HISTORIC LANDMARK COMMISSION
APPLICATION FOR A CERTIFICATE OF APPROPRIATENESS
NOVEMBER 15, 2021
C14H-2009-0029; HR-2021-148730
DAVIS HOUSE
1600 GASTON AVE.

PROPOSAL

Construct a second-story addition over the garage.

SITE
PLAN

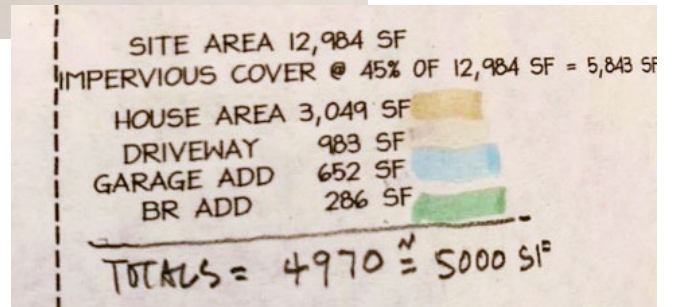
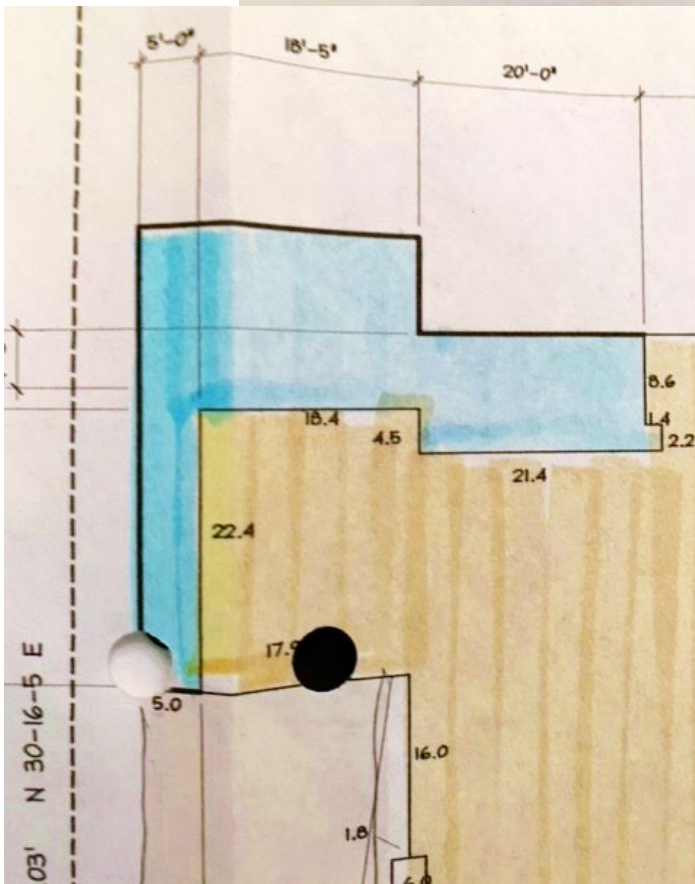
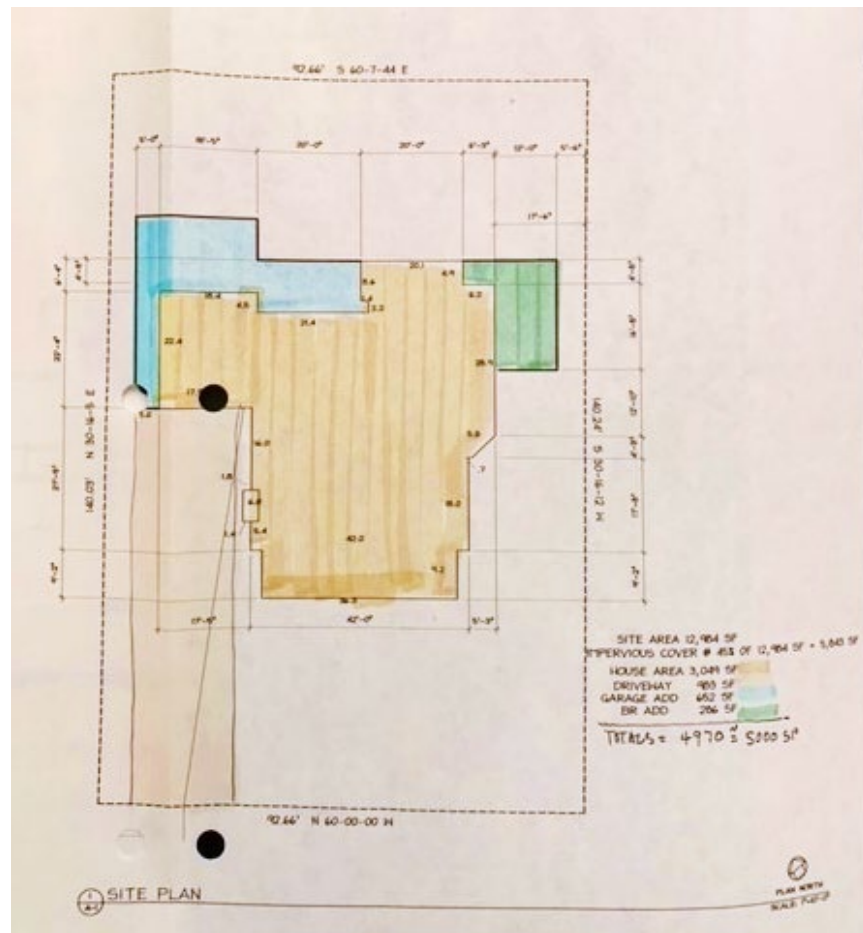
Building permit records indicate the garage was enlarged and rebuilt when other additions were made to the house in 2004, before the house became a landmark. No additional drawings, such as a demolition plan or elevation showing the changes to the garage, are currently available in permit records. Note the entire garage roof was replaced.
